SUBJECT: KINGSTON STEAM PLANT - ANNUAL JOINT INSPECTION OF THE ASH DISPOSAL AREAS BY
OE AND F&H PR

KINGSTON STEAM PLANT

ASH DISPOSAL AREAS

TITLE KINGSTON STEAM PLANT - ANNUAL JOINT INSPECTION OF THE ASH DISPOSAL AREAS BY OE AND F&H PR		REPORT NO. 85-20	
		PLANT/UNIT	
		SAR SECTIONS	
VENDOR	CONTRACT NO.	KEY NOUNS	
	REV	(FOR MEDS USE)	MEDS ACCESSION NUMBER
APPLICABLE DESIGN DOCUMENTS	R0		B41 85 0 709 004
	R1		
	R2		
REFERENCES	R3		
	R4

ASH POND DIKE
PLAN-RAISING ASH DISPOSAL
AREA DIKE

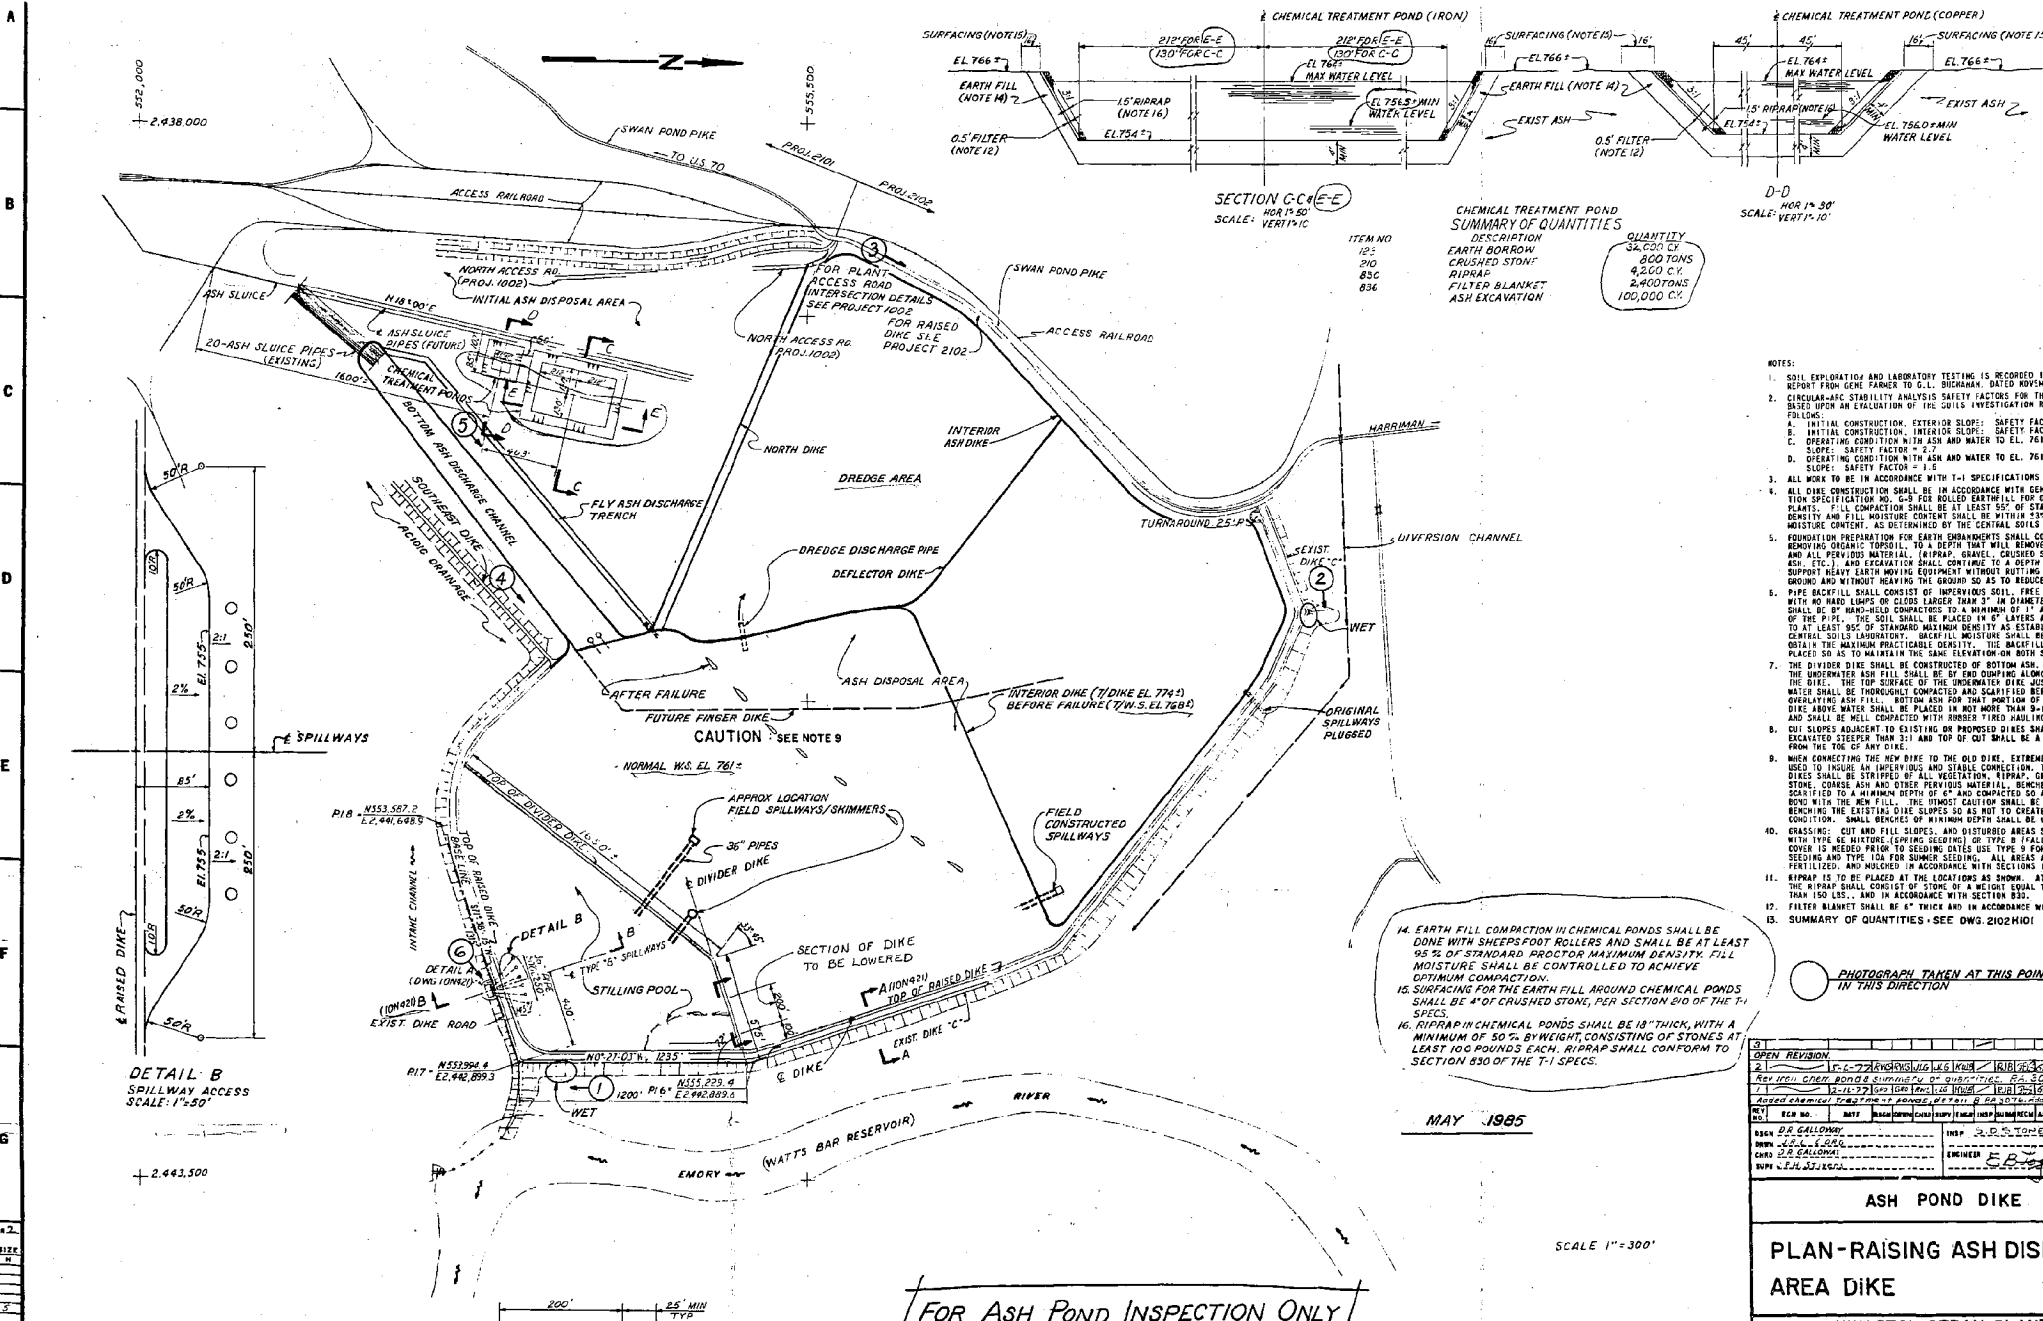
- 6.6 In order to reduce the potential for ash pond water to overflow the perimeter dikes, plant personnel should lower the top of the divider dike by two feet to elevation 763 for a length of 200 feet along the dike. The recommended location of and a section taken through the portion of the dike to be lowered is shown on the attached print of drawing 10N420.
